Re Union Mutual Project
Portland, Maine - 121

Re: Union Mutual Office Project
Portland, Maine
Request for alternate use of
Inland Steel Deck Product

Ref: Union Mutual Office Project, Portland, Maine
Request for omission of fireproofing per
letter of Jan. 21, 1969.

Re: Union Mutual Office Bldg. Live Load Reduction Request

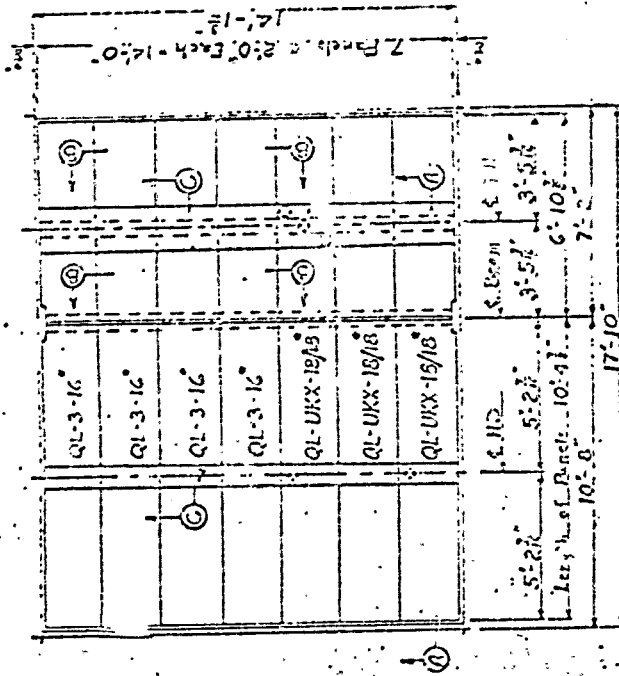
Please be advised that a floor and ceiling assembly constructed as shown on the enclosed copy of the construction drawing was subjected to a fire endurance test on February 28, 1967. The test was conducted in accordance with the Standard Fire Tests of Building Construction and Materials U2203, (ASTM E119, NFPA 251).

The test assembly consisted of lightweight concrete, aggregate manufactured by rotary kiln process, supported by your 1-1/2 in. deep composite form units, designated QL-UM and QL-3, and by a steel beam. The steel beam was protected with a sprayed fiber fireproofing material manufactured by U. S. Mineral Products Co., and designated Type D.

The engineering work on this fire-test investigation has not been completed, but upon completion a detailed formal Report of File R2689-10 will be prepared wherein we will classify the test assembly as a 2-hr fire-resistive construction with a 3-hr beam rating. This Report will be sent to our Fire Council for their review and acceptance. Because of excessive temperature transmission through the trench header and header ducts shown on the enclosed drawings, these components will not be included as part of the 2-hr fire resistive construction.
